Commission Agenda Report

Planning Commission Meeting
05-18-26
Item 4.A.

Subject: Coastal Development Permit No. 23-073, Variance No. 25-019, Site Plan Review No. 23-035, and Minor Modification No. 24-005 – An application for the construction of a single-family residence and associated development (Continued from March 16, 2026)

Location: 32832 Pacific Coast Highway, within the appealable coastal zone
APN: 4473-017-023
Owner: Sun is Shining, LLC

TOTAL DEVELOPMENT SQUARE FOOTAGE DIAGRAMS

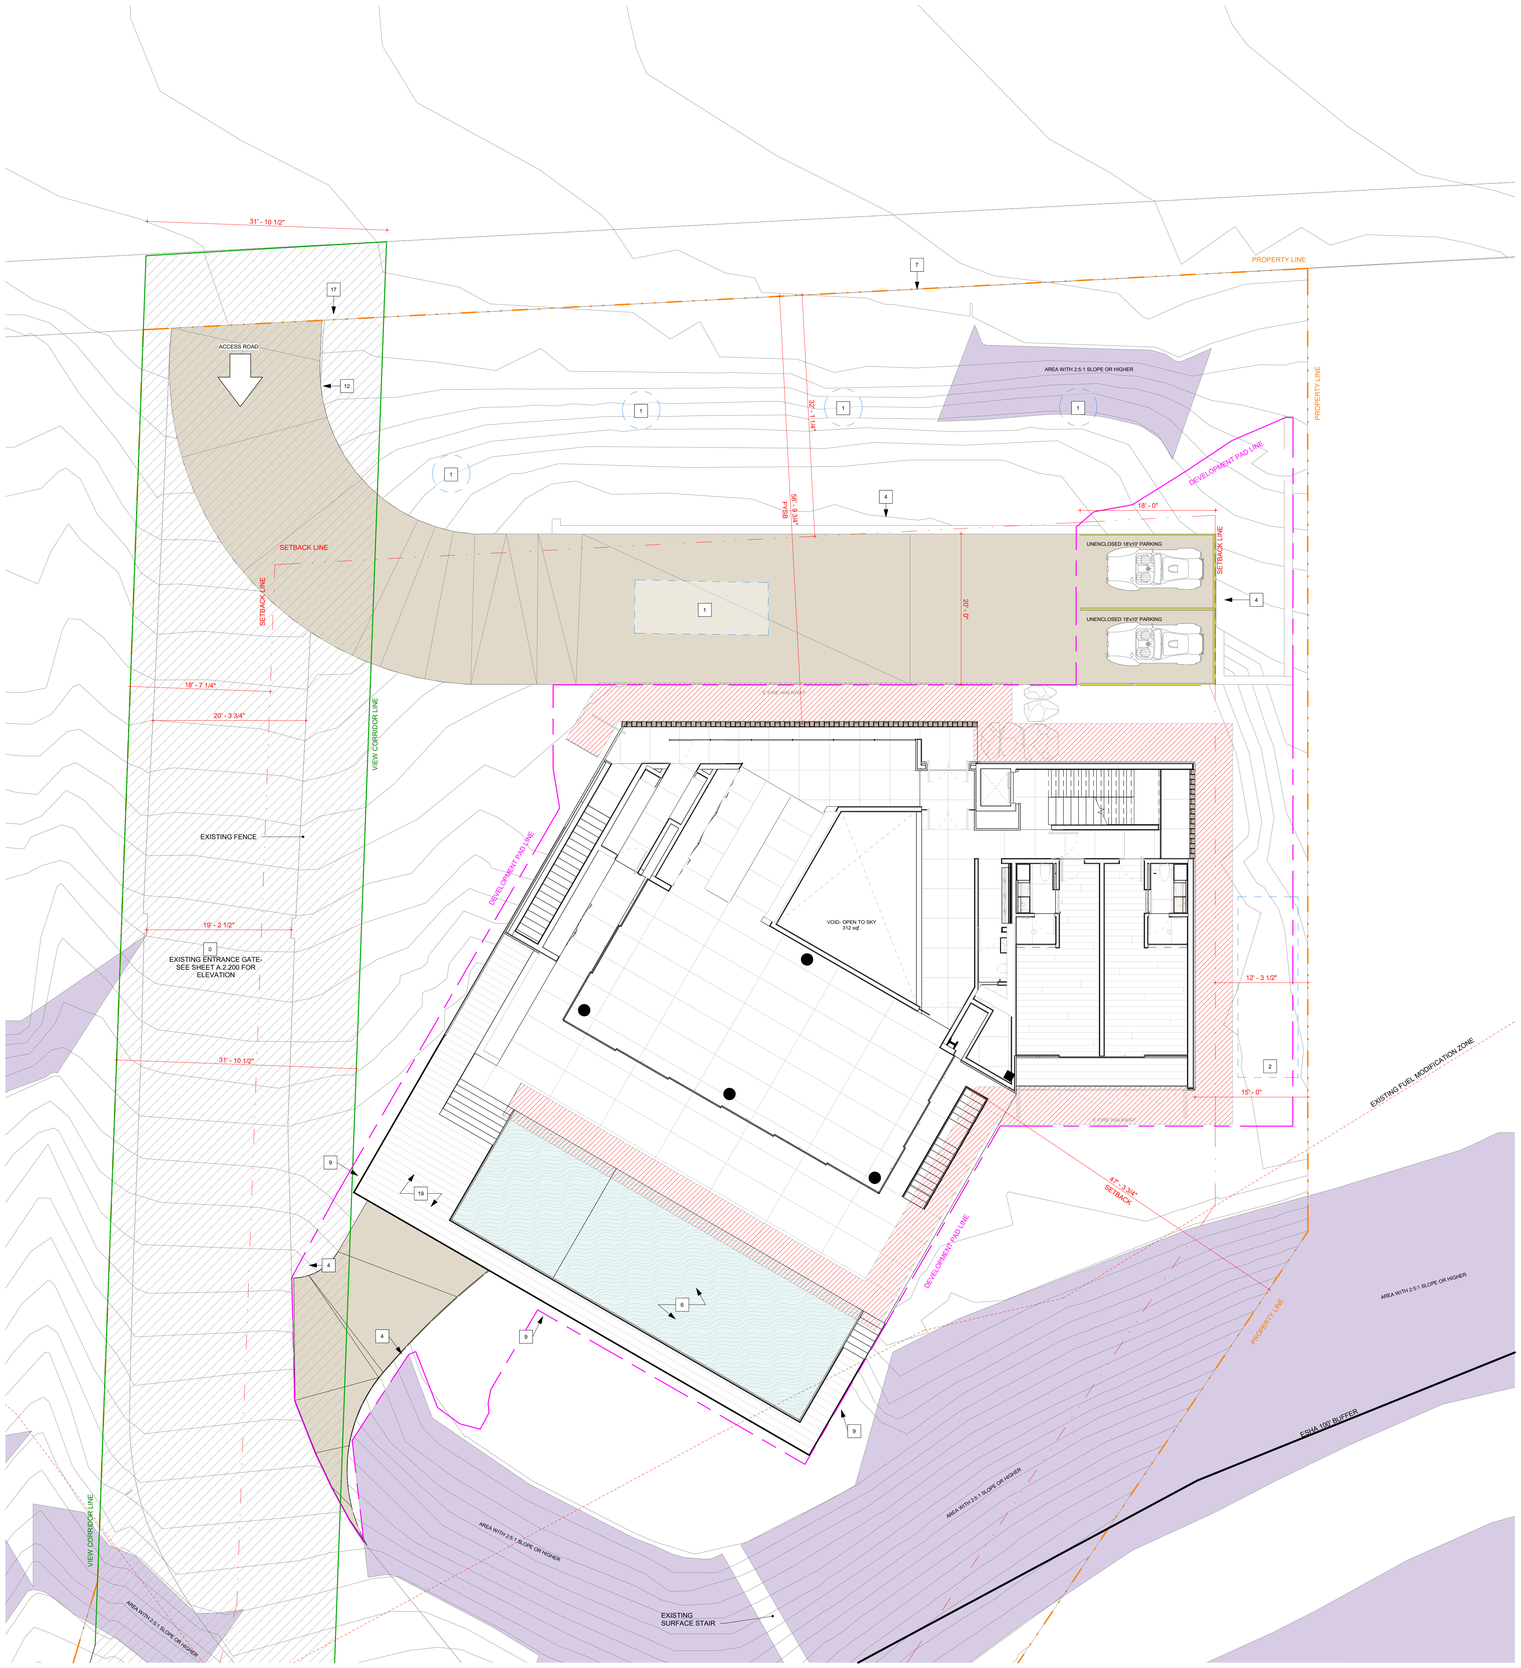
At the March 16th meeting, the Commission requested clarification on whether any proposed roof overhangs or covered deck and patio areas exceed six feet in depth, which would require inclusion of those areas in the TDSF calculation under the LIP[1].

The revised plan set dated April 14, 2026, includes updated drawings with dimensions, labels specifying areas "open to the sky," and a TDSF General Notes on Sheet A-041, which states: "COVERED AREAS 6' OR GREATER = 0 SF." The plans confirm that the

Staff has reviewed the revised plans and finds this confirmation consistent with the design shown. The TDSF in Table 3 (Updated Zoning Conformance) of this report reflects the project's verified TDSF of 6,184 square feet, which is less than the maximum allowed TDSF of 6,259 square feet.

Proposed view Corridor

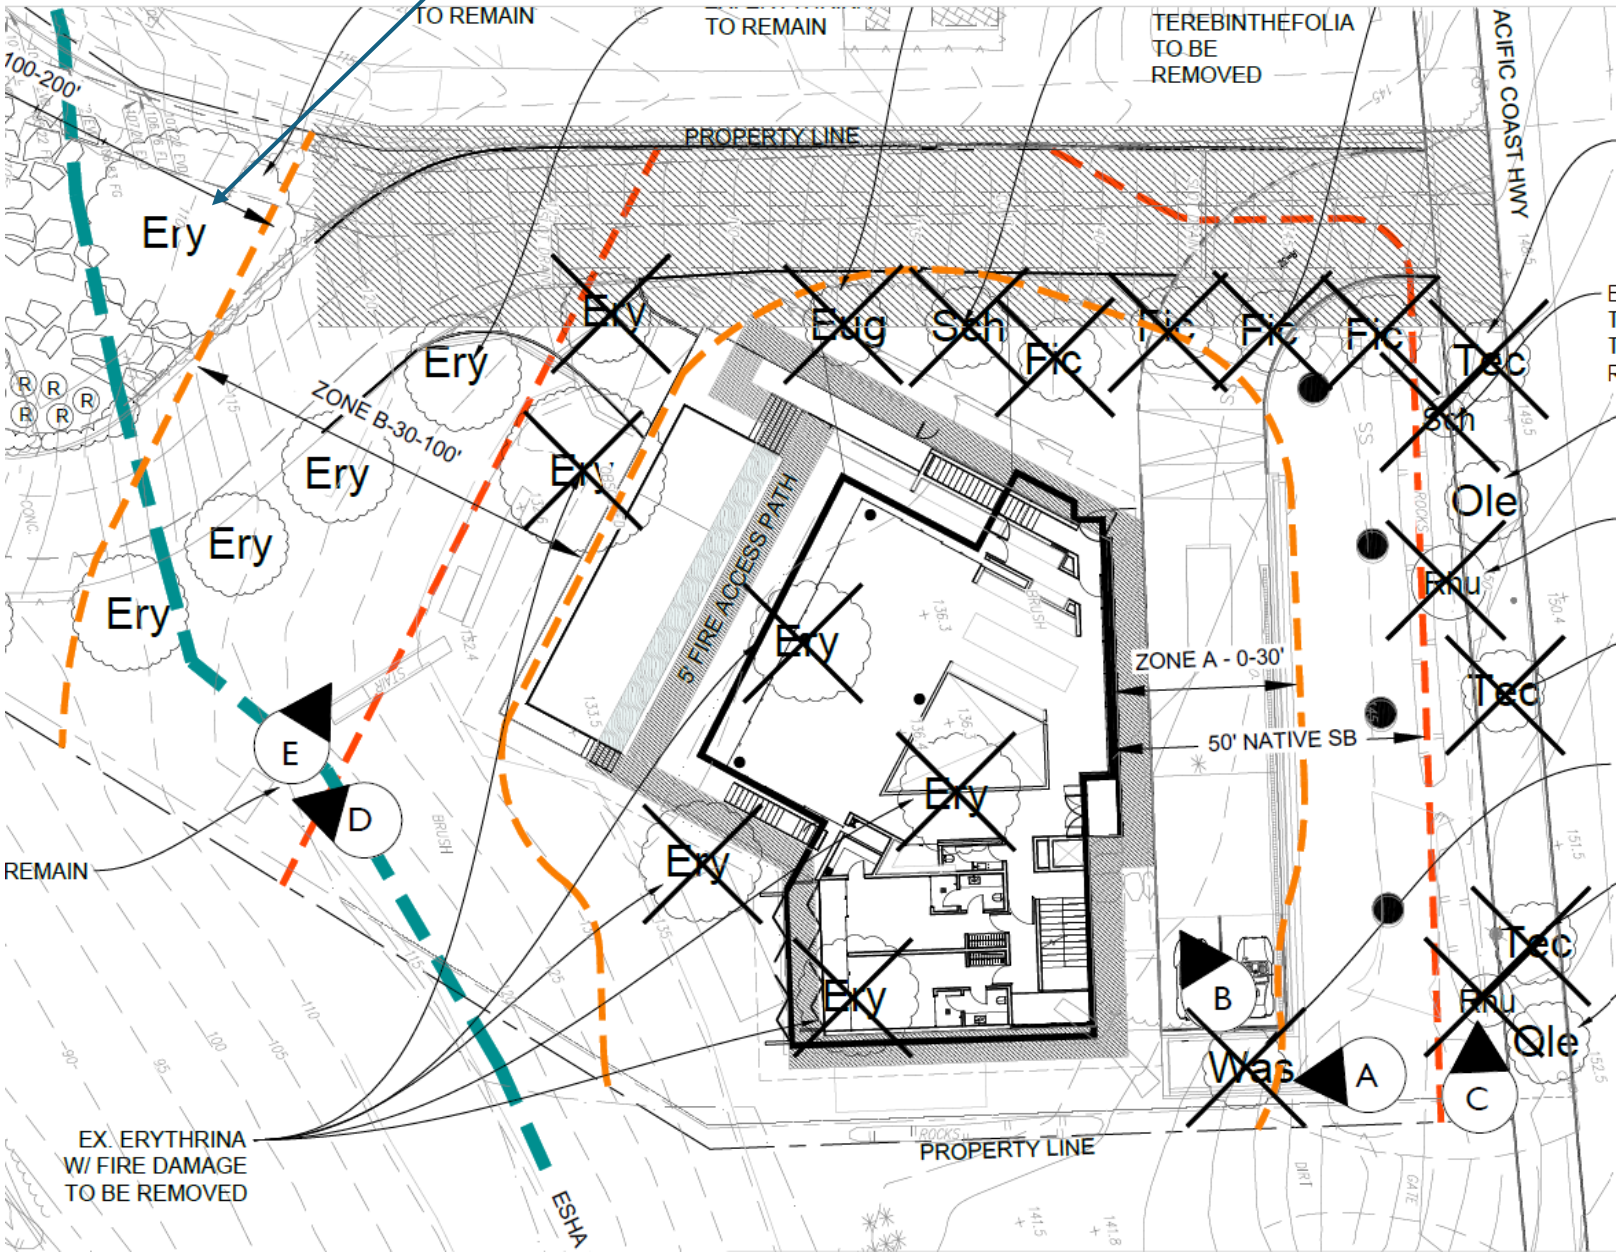
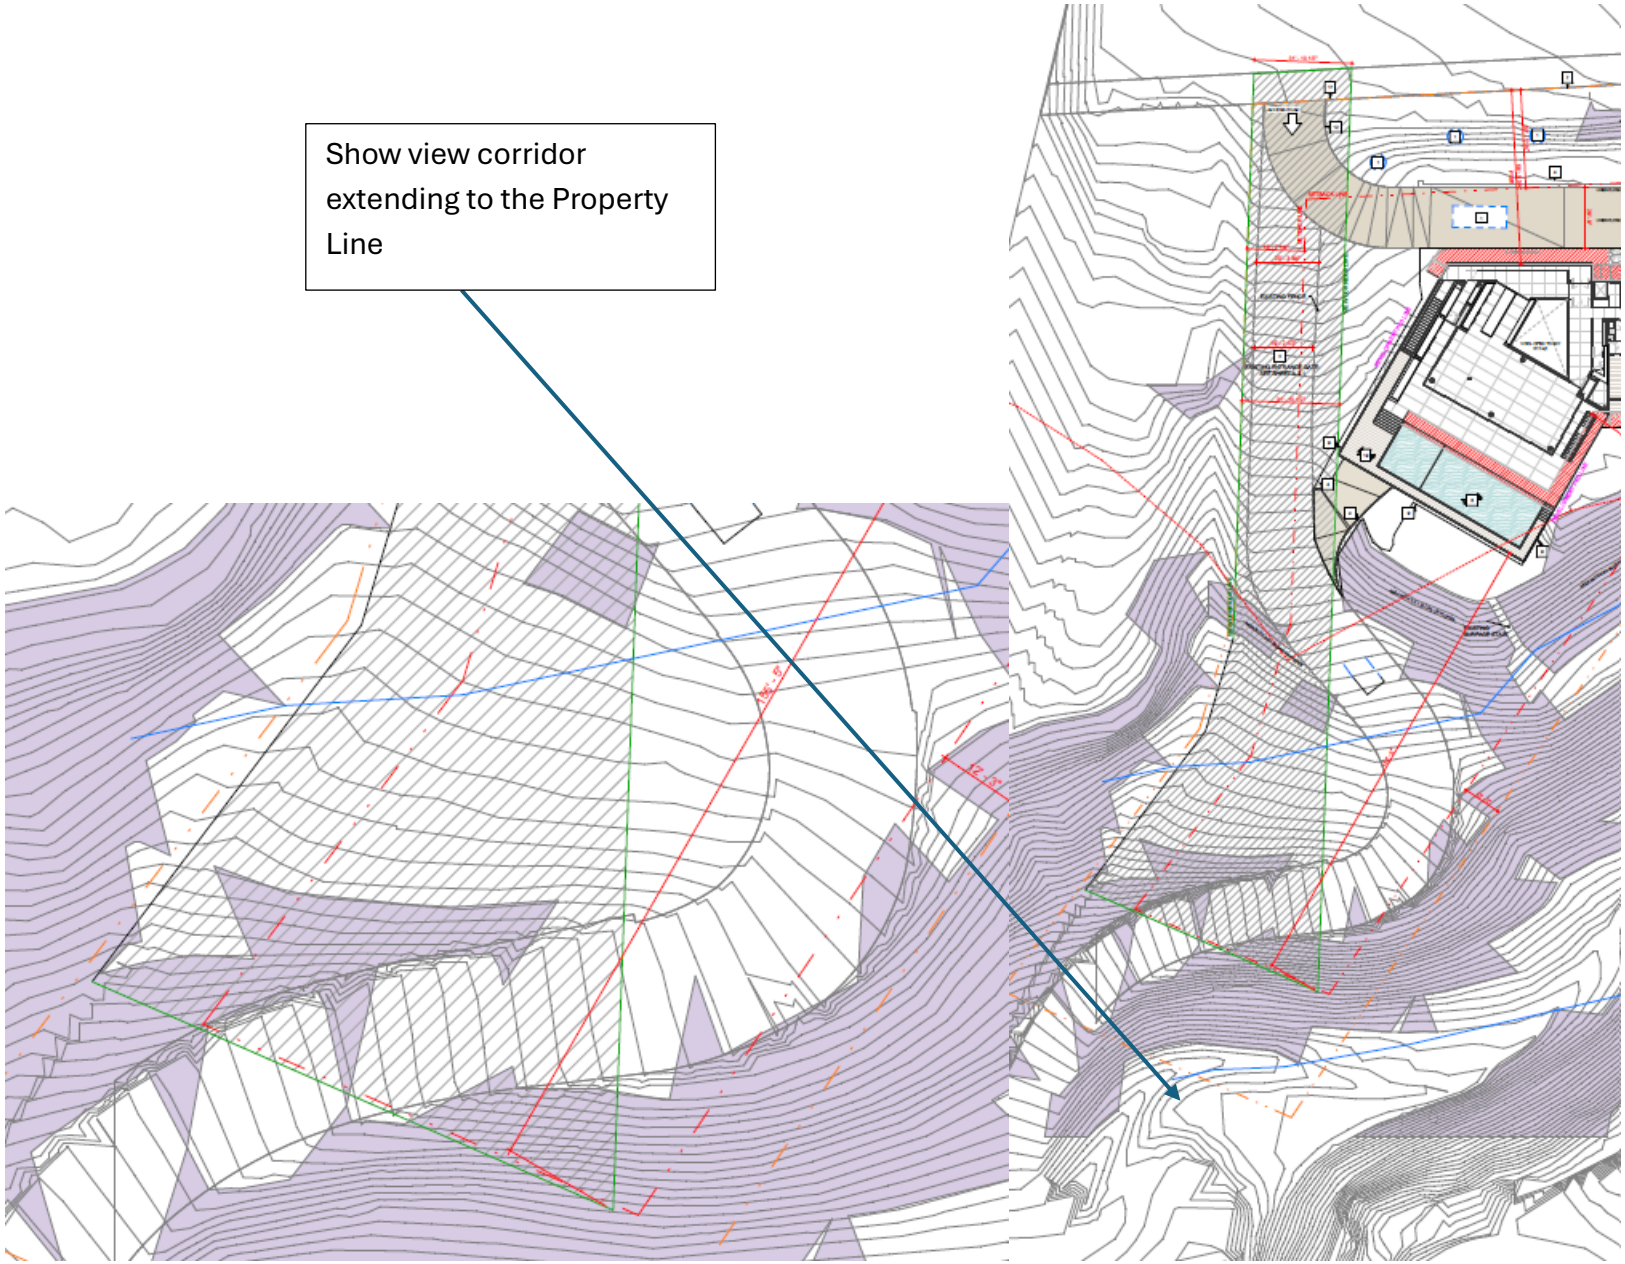
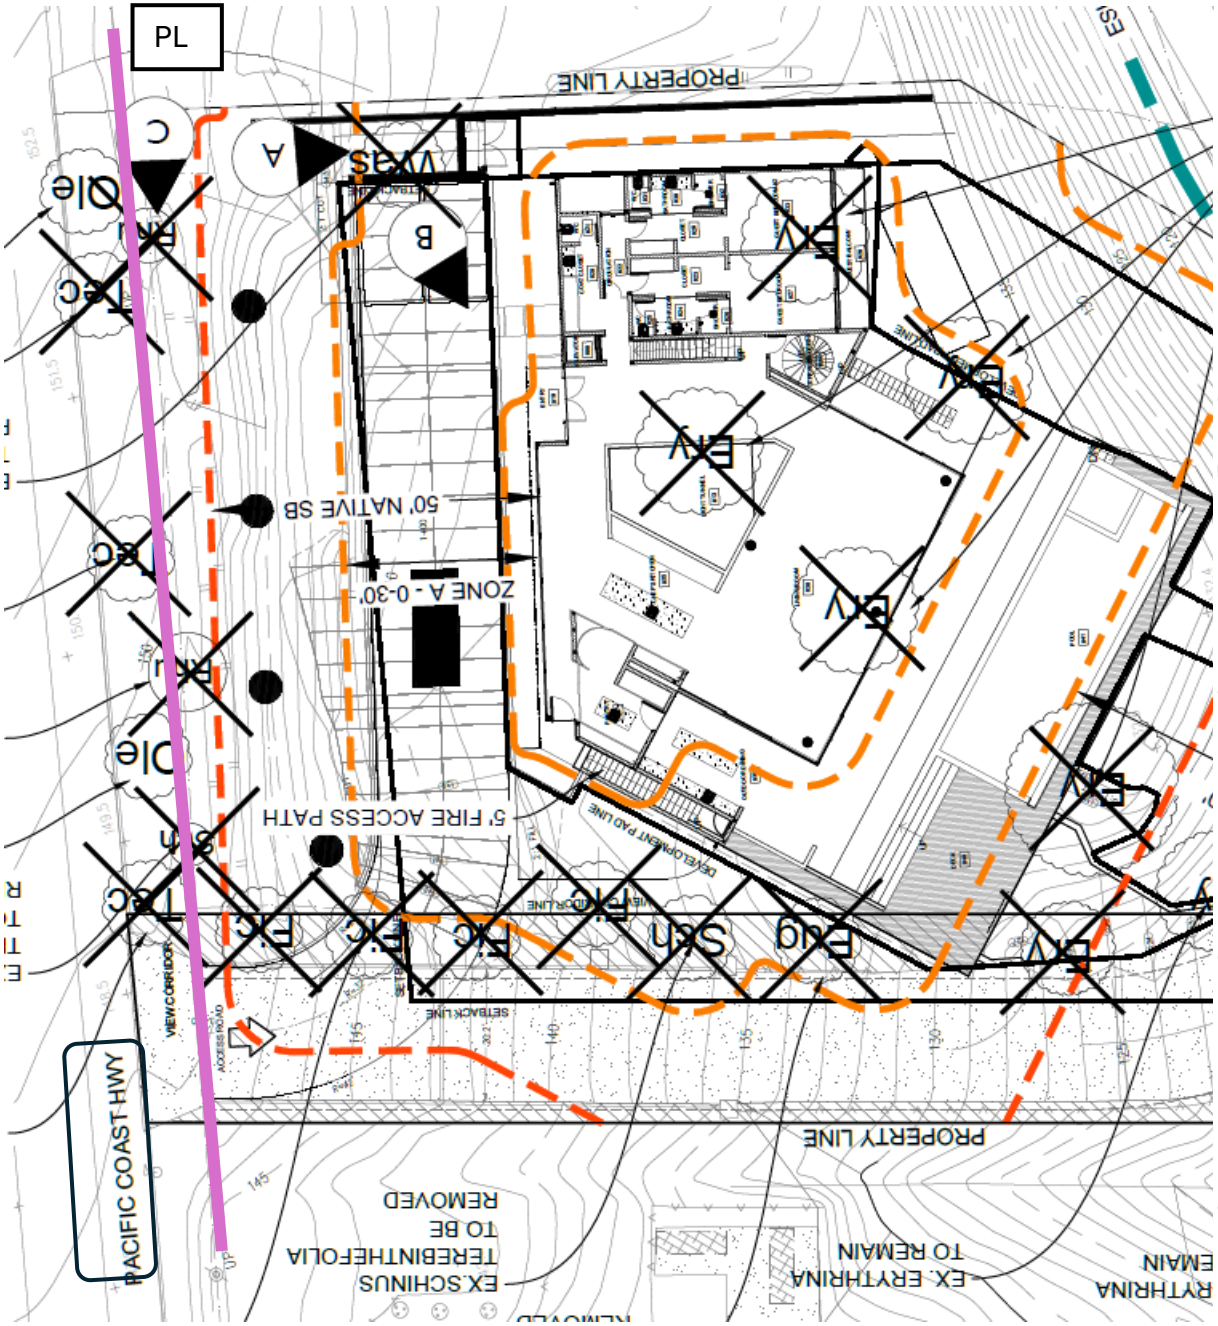
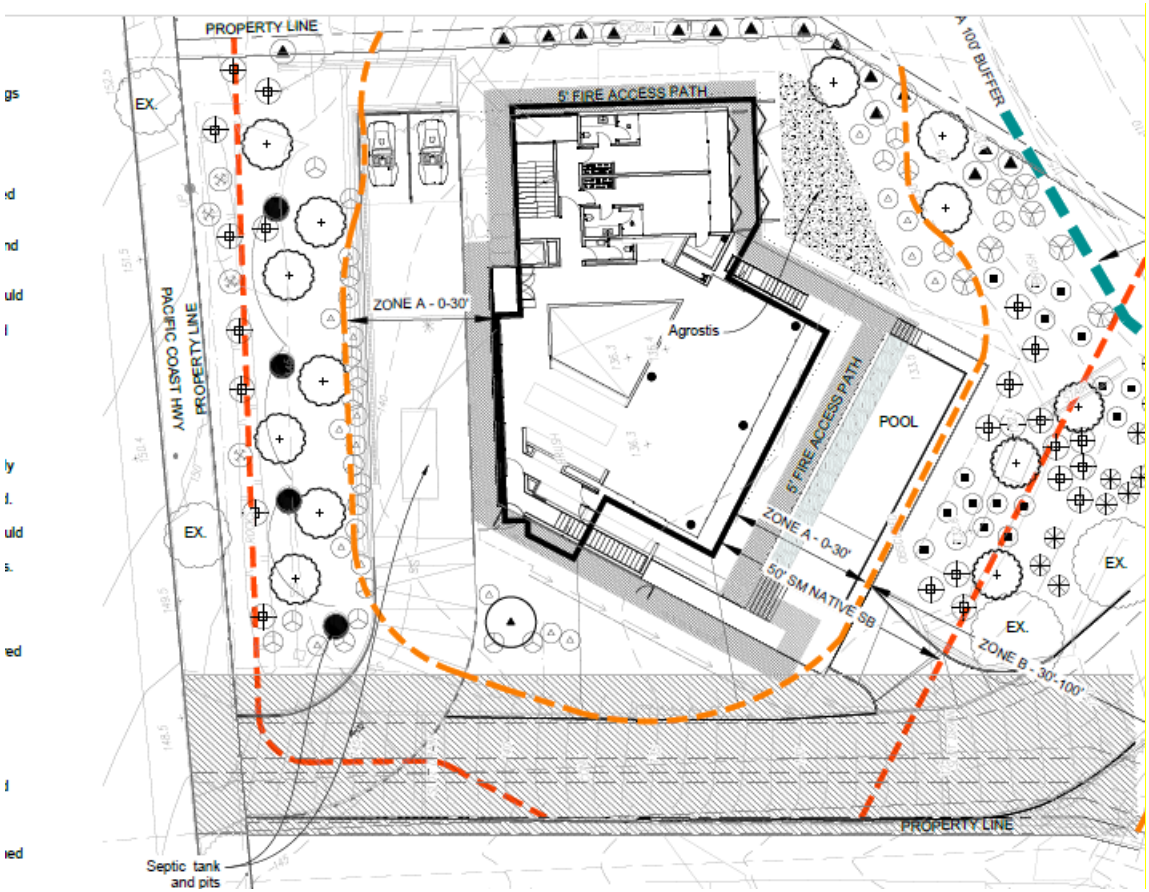
At the March 16th meeting, the Commission requested additional information on how the required public view corridor[2] was established, including its location on the subject parcel, vegetation maintenance within the Caltrans right-of-way, and a question regarding a tree near the base of the driveway.

tree. However, staff's evaluation of the tree within the view corridor is that it does block bluewater views as seen from PCH as shown in Figure 1 below. The tree in question is not a native protected tree under Chapter 5 of the LIP and has not been demonstrated to contain special status species. Therefore, staff is recommending the tree be removed to open up the required view corridor from PCH. The view corridor is also conditioned to be maintained for the life of the property. Conditions have been placed within the resolution to address the tree's removal and maintenance of the view corridor.

All trees within the proposed view corridor that extend above road grade are proposed to be removed in order to open and preserve ocean views. The site topography drops significantly from PCH, which inherently enhances view opportunities as the parcel descends.

The tree at the bottom of the driveway referenced by the Commission is located on the subject parcel; however, it was installed by the neighboring property owner as part of their entry landscaping. In an effort to maintain good neighbor relations, the owner has sought to retain this tree unless its removal is necessary to achieve compliance.Because the tree is located largely below road grade and is regularly maintained, it does not create a material obstruction to ocean views. To further address this, the owner has proposed a wider view corridor than otherwise required by Code, thereby offsetting the retention of this tree.

Additionally, the project proposes a more expansive view corridor along the ocean-facing portion of the parcel to meet the intent of the view corridor provisions, even though this approach exceeds the strict language of the Code. While the Code contemplates corridors running parallel to property lines, the proposed design extends the line of sight along the length of the parcel to maximize available views.

The vegetation on the left side of the purple line (PL) is off-site and within the Caltrans ROW and subject to Caltrans authorization. The owner is proposing to remove the Tecomaria shrubs, which is a fast growing screening shrub. Two fruitless olive trees on either side of the property are proposed to remain.
